# Technical Journal

**TITLE:**  
**Squeaking noise from subframe bushings / Reinforcement plate**

<b>REF NO:</b> TJ 17644	<b>ISSUING DEPARTMENT:</b> Technical Service	<b>CAR MARKET:</b> United States and Canada
<b>PARTNER:</b> 3 US 7510 Volvo Cars North America		<b>ISSUE DATE:</b> YEAR MONTH DAY 2013 07 15
<b>FUNC GROUP:</b> 2182	<b>FUNC DESC:</b> Rubber cushion	Page 1 of 6

## CONTACT POINTS

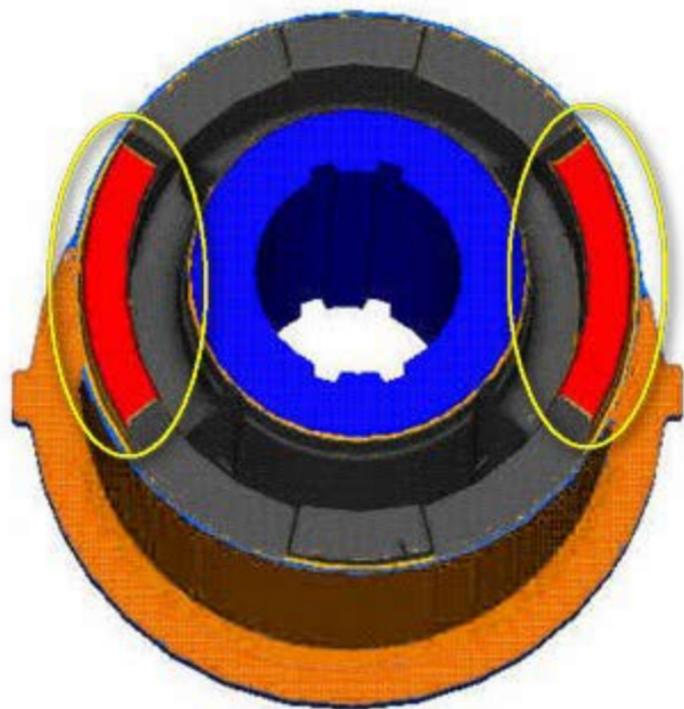
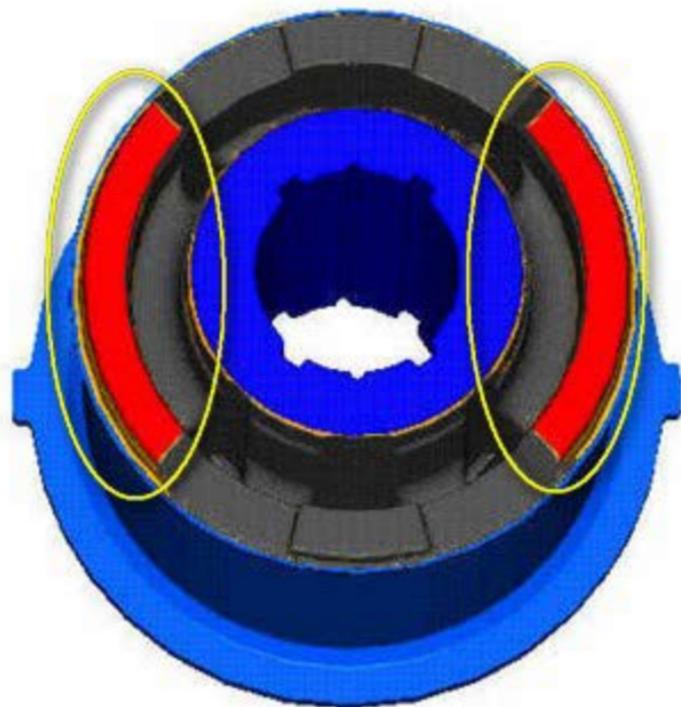
The noise usually comes from the rear bushings in the front subframe due to axial travel resulting in a rubbing or squeaking noise between the reinforcement plate and the bushings' front and rear axial movement limiters.

Once the rubber material on the bushing is worn out, the underneath plastic material may cause a soft knocking noise instead. The contact points are illustrated in the attached pictures: TJ 17644 -1.jpg; TJ 17644 -2.jpg

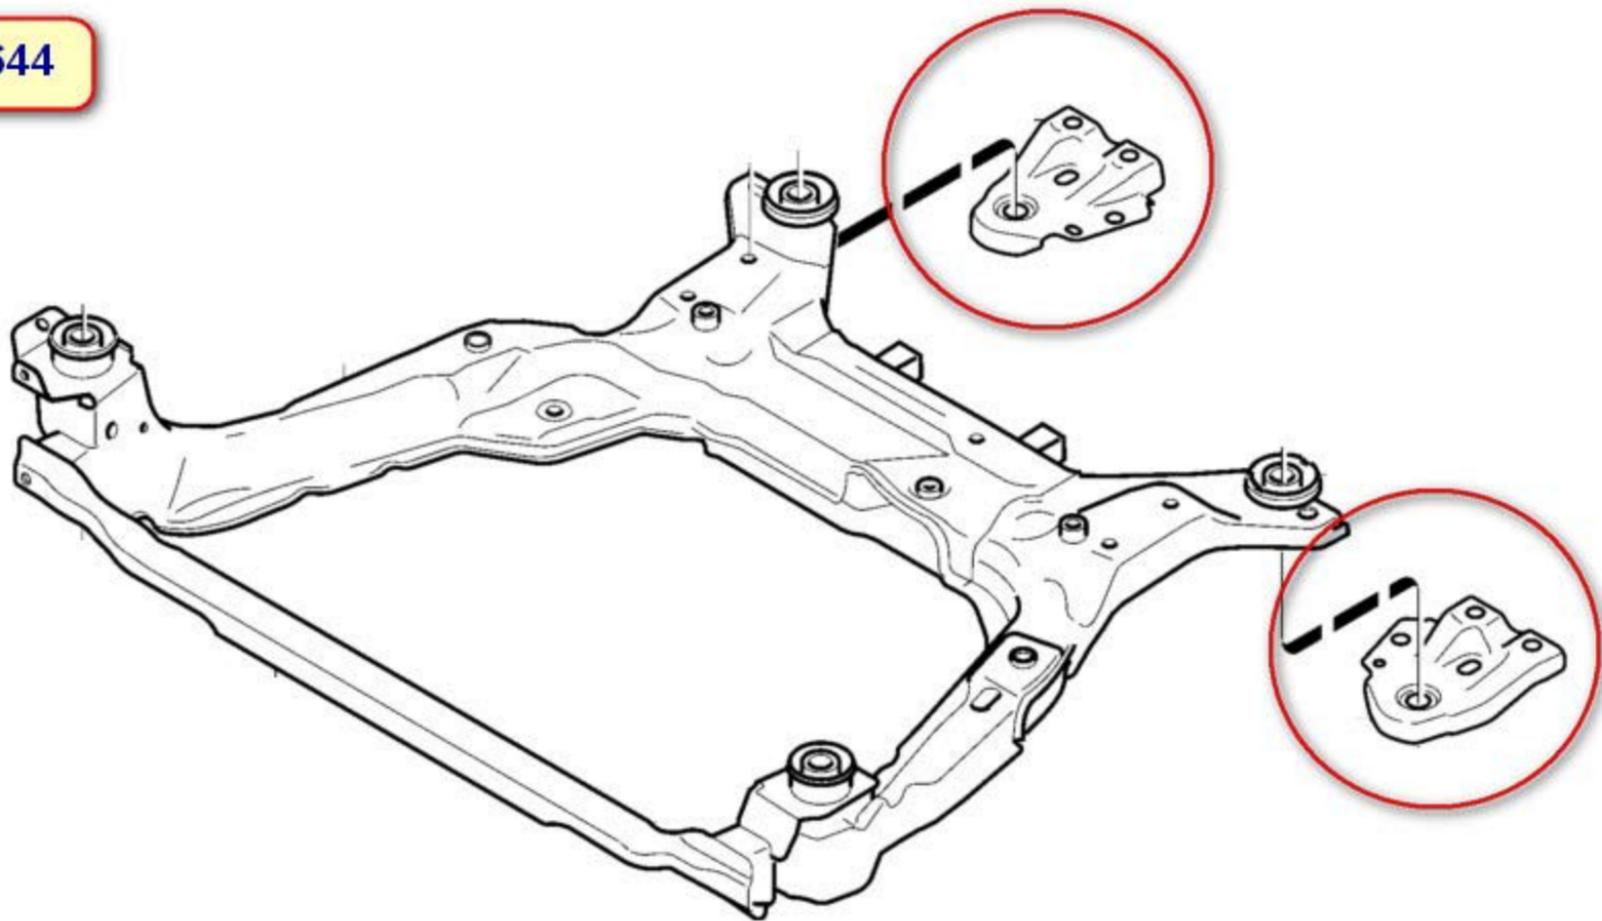
If this customer's complaint is verified, replace both right and left side reinforcement plates, refer to attached picture TJ 17644 -4.jpg.

Reinforcement plate, Left side: PN 31391780

Reinforcement plate, Right side: PN 31391781

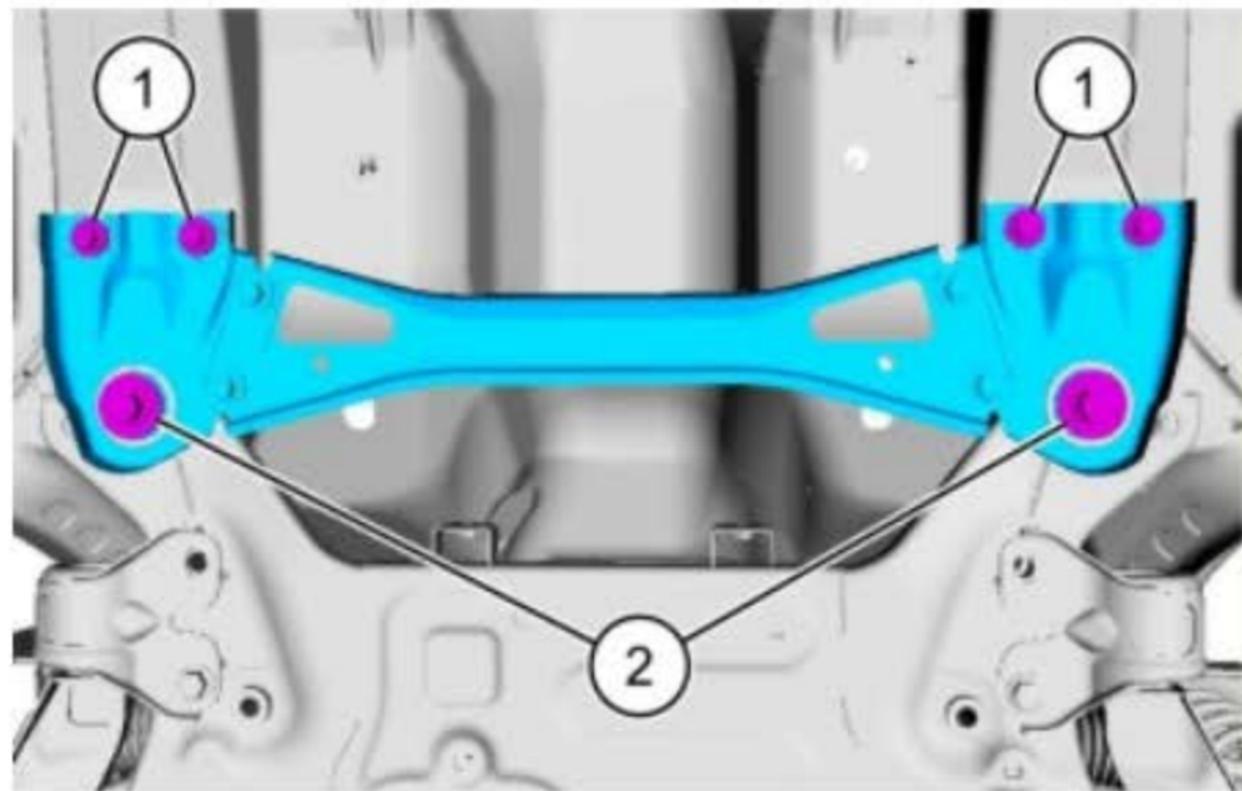
Torque specifications can be found in the attached picture TJ17644 -3.jpg

1. **Torque:** M8, 24 Nm
2. **Torque: Subframe to chassis (Rear screws)**
  - Stage 1: 150 Nm
  - Stage 2: 90 °
